UNITED STATES ENVIRONMENTAL PROTECTION AGENCY

Re: EPA Comments on California Asphalt Production, Inc.'s April 1, 2019 Work Plan
RCRA 3013-09-2019-0001

EPA Comments to the California Asphalt Production, Inc. Work Plan, dated April 1, 2019

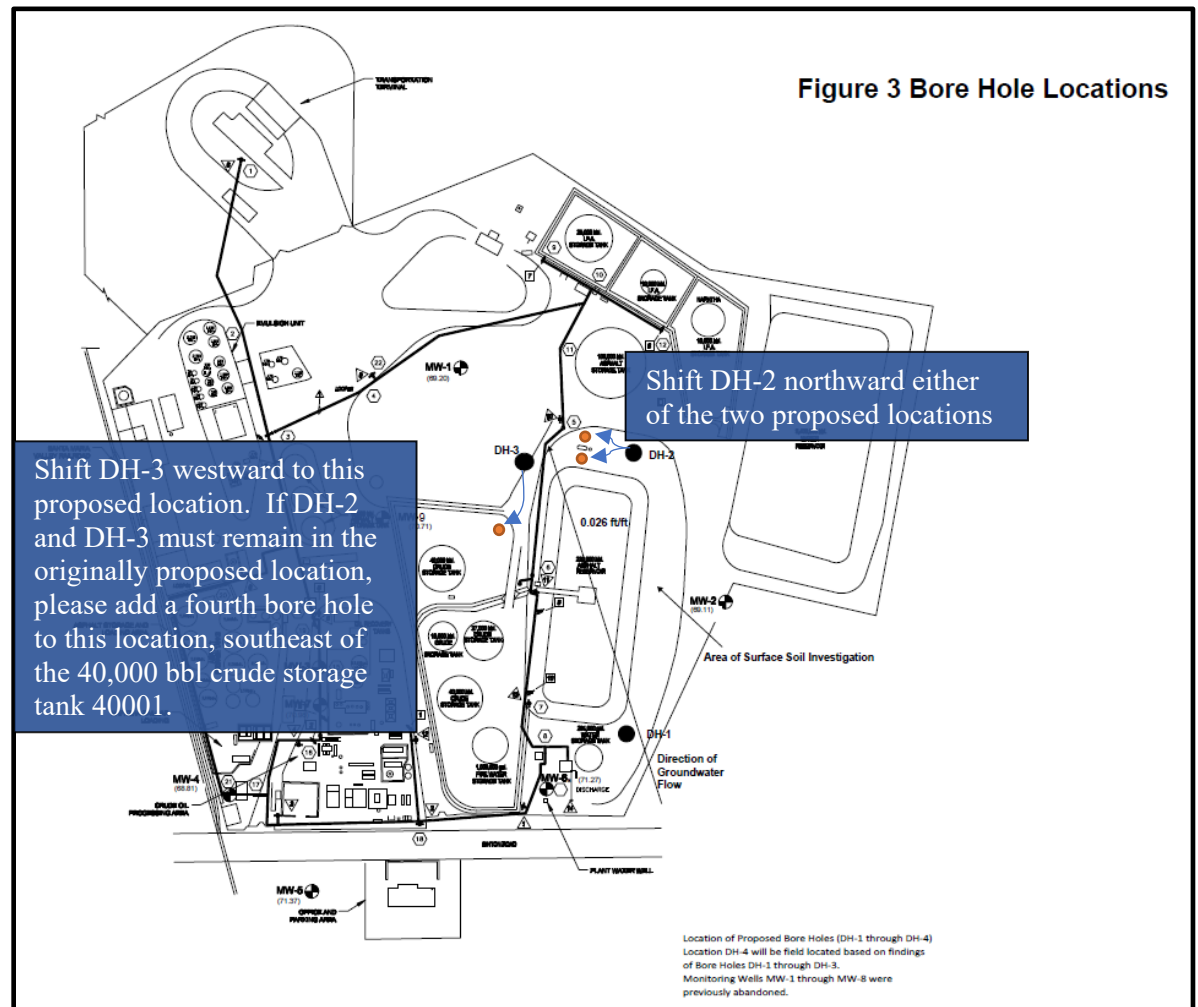
- b. EPA is in agreement with the proposed location of boring DH-1. EPA reviewed groundwater data from the California Regional Water Quality Control Board and other sources to evaluate the direction of groundwater flow around the California Asphalt Production facility. Based on this review, EPA suggests moving the locations DH-2 and DH-3, as shown below. If moving the locations of DH-2 and

DH-3 is unworkable, EPA suggests installing an additional monitoring well between crude oil storage tank 40001 and the surface impoundment, also shown below.
